**Before the
FEDERAL COMMUNICATIONS COMMISSION
Washington, D.C. 20554**

AMENDMENT

ECHOSTAR EX-5

ATTACHMENT A

Figure 1. PFD contours of the CONUS beam with a peak downlink EIRP of 59.6 dBW.

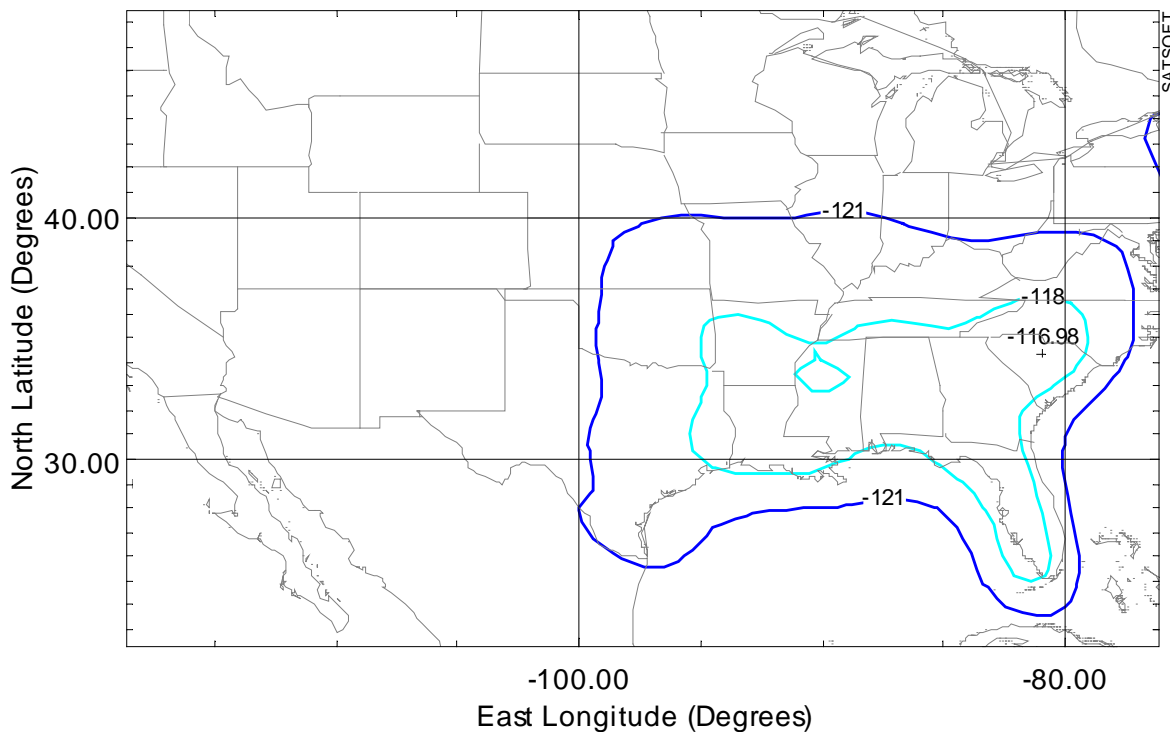
The maximum downlink EIRP of the CONUS beam is 60.2 dBW. With this EIRP level, a PFD analysis shows that the maximum PFD levels produced in the four regions defined by §25.208(w) are met, except for the region defined by §25.208(w)(3). In order to comply with the PFD level of §25.208(w)(3), EchoStar will reduce the maximum downlink EIRP of the CONUS beam to be 59.6 dBW. EchoStar will not operate the CONUS beam with a downlink EIRP greater than 59.6 dBW unless higher-powered operations are coordinated with adjacent, authorized 17/24 GHz BSS operators as allowed by §25.262(f)(1).

With a maximum downlink EIRP of 59.6 dBW, the maximum PFD level that the CONUS beam is capable of producing is $-116.98 \text{ dBW/m}^2/\text{MHz}$. This occurs in the southeast portion of CONUS. Figure 1 shows the geographic location of the maximum PFD and the $-118 \text{ dBW/m}^2/\text{MHz}$ and $-121 \text{ dBW/m}^2/\text{MHz}$ contours. The diagram demonstrates that, with a peak downlink EIRP of 59.6 dBW, the CONUS beam is in compliance with §25.208(w).

Figure 4. -121 dBW/m²/MHz PFD contour (blue) of beam SP06 with an EIRP of 63.4 dBW.

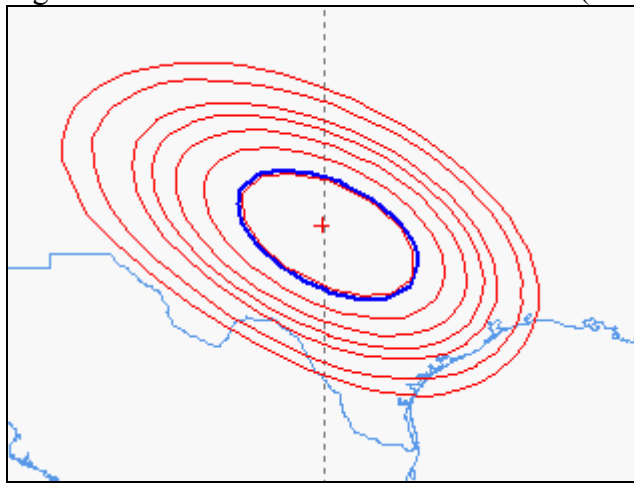
The boresight of beam SP06 is slightly west of 100° W.L. Figure 4 shows the -121 dBW/m²/MHz PFD contour of the beam if it were to transmit with its maximum downlink EIRP of 63.4 dBW. The beam has the capability of exceeding the PFD level of §25.208(w)(3) by 2.3 dB. In order to comply with the PFD level of §25.208(w)(3), EchoStar will reduce the maximum downlink EIRP of beam SP06 by 2.3 dB. EchoStar will not operate beam SP06 with a downlink EIRP greater than 61.1 dBW unless higher-powered operations are coordinated with adjacent, authorized 17/24 GHz BSS operators as allowed by §25.262(f)(1).

Figure 5. $-121 \text{ dBW/m}^2/\text{MHz}$ PFD contour (blue) of beam SP12 with an EIRP of 63.4 dBW.

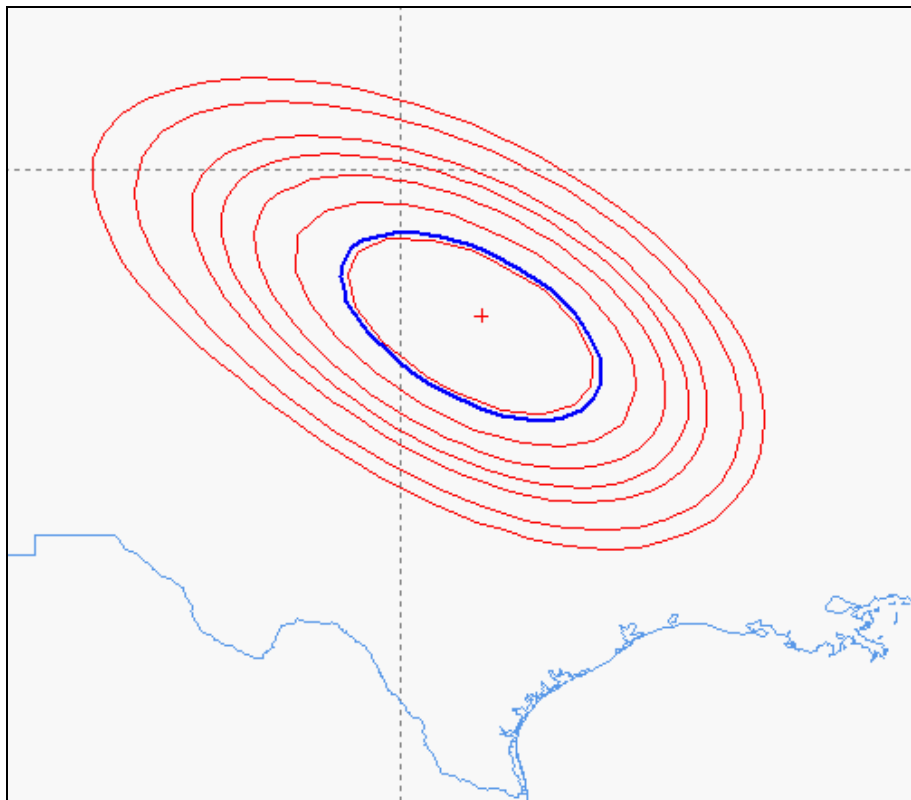
Figure 5 shows the $-121 \text{ dBW/m}^2/\text{MHz}$ PFD contour of beam SP12 if it were to transmit with its maximum downlink EIRP of 63.5 dBW. The beam has the capability of exceeding the PFD level of §25.208(w)(3) by a maximum of 1.1 dB. In order to comply with the PFD level of §25.208(w)(3), EchoStar will reduce the maximum downlink EIRP of beam SP12 by 1.1 dB. EchoStar will not operate beam SP12 with a downlink EIRP greater than 62.4 dBW unless higher-powered operations are coordinated with adjacent, authorized 17/24 GHz BSS operators as allowed by §25.262(f)(1).
